## 3M Pleated Foil Cable and Connector Termination Issues

Cabling for the SVX Sequencer to Interface Boards requires that the shield be used as a ground return for the signals. Recently it has been determined that the cable assemblies from outside vendors vary from the proposed 3M assembly instructions. Additionally we have determined the need for a better long term reliable ground connection from shield to connector case.

Figure 1

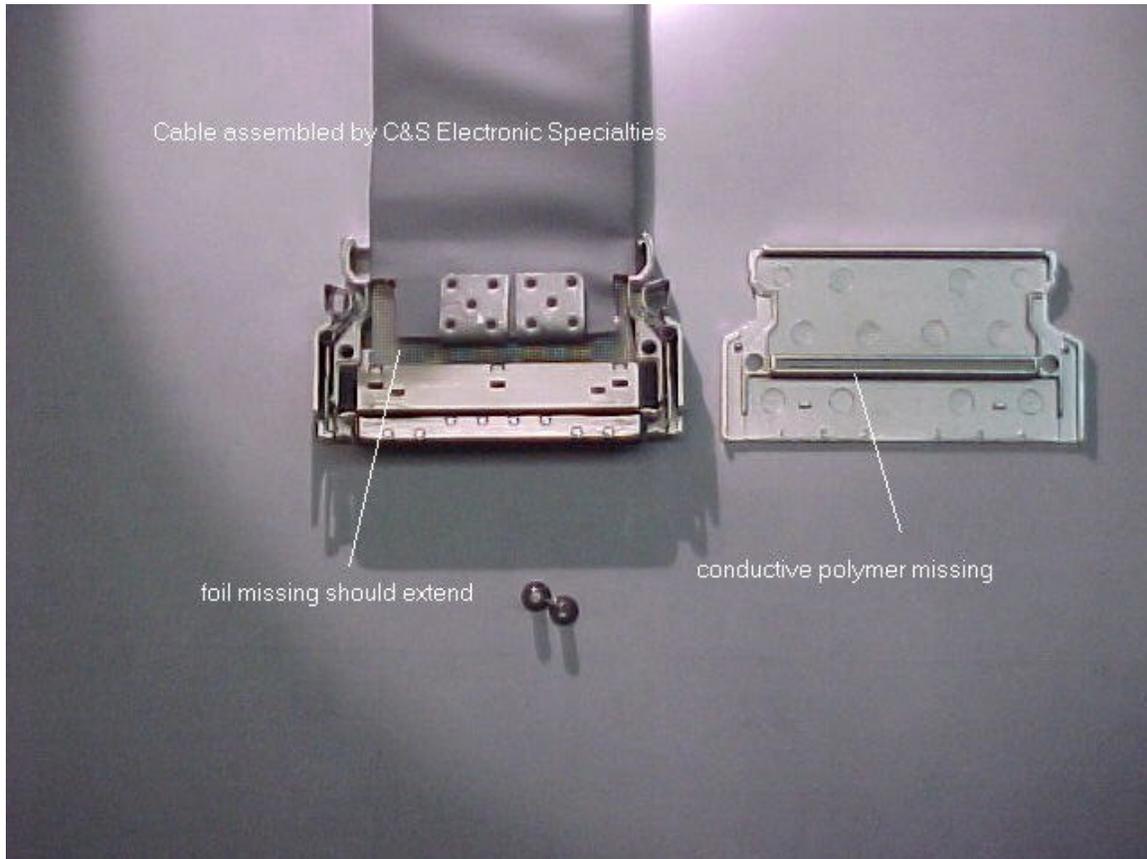
Please note in the above picture that no foil shield is exposed. The elastomer is missing from the connector shell. The result is a poor ground to the foil shield. Pictured above is plated foil cable type 90201/68 with a 10168-6000EC connector and a 10368-A230-00 metal shell.

After the signal conductors are swaged onto this connector the pleated foil shield will need to be lapped to the metal part of the connector and secured by a stable adhesive such as conductive epoxy. This will insure a good 100% coverage of the signals to the connector termination.

The connector shell kit comes with a conductive elastomer that assures a good connection from the shell to the pleated foil shield. The elastomer is included with the metal shell assembly. In one of the assemblies I received the elastomer was not installed.

Figure 2

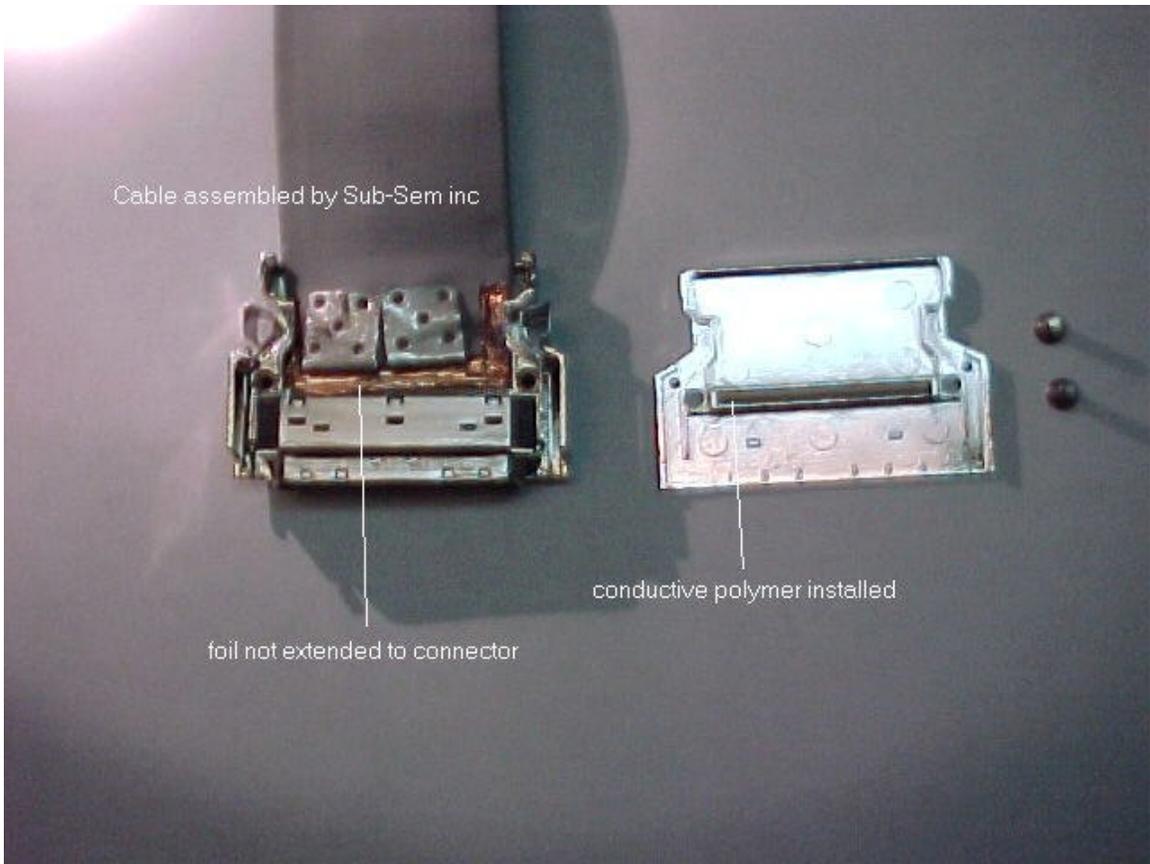
This example shows that the foil shield does not make contact with the connector housing. Better than example 1 since the conductive elastomer will make contact with the shield. Pictured above is 90211/50 cable with a 10150-6000EC connector and a 10350-1230-00 connector shell.

Figure 3

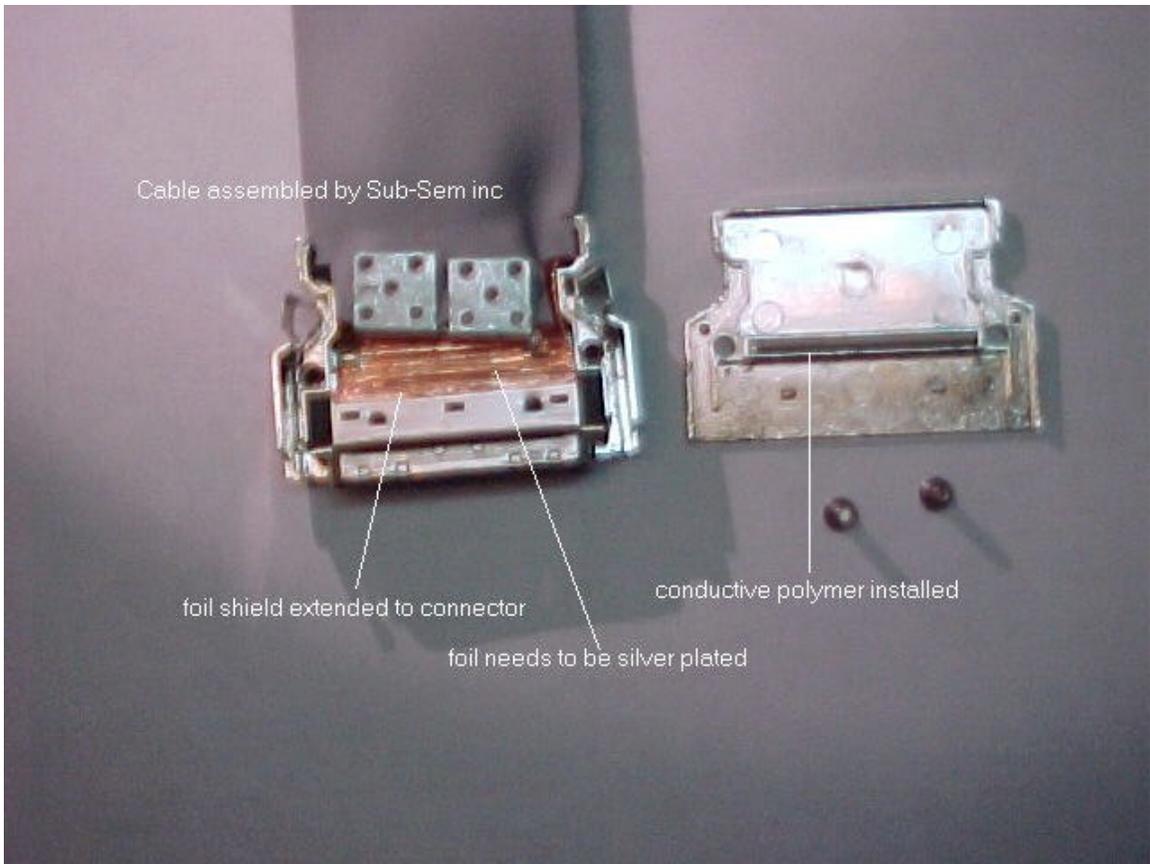
This example is closest to the desired termination. The only thing missing is the silver plating of the shield in the area where the elastomer contact is made. Pictured above is 90211/50 cable with a 10150-6000EC connector and a 10350-1230-00 connector shell.

The area of the cable where the silicone elastomer connects to the pleated foil shield will need to be plated with silver. This will insure that the ground connection will not become corroded and fail to make contact. A silver plating solution is available called Cool-Amp silver plating powder. The powder is mixed with water into a paste that is worked onto the shield with a rag or swab. The shield surface is then rinsed with water and dried. The spec sheet is found at this URL.
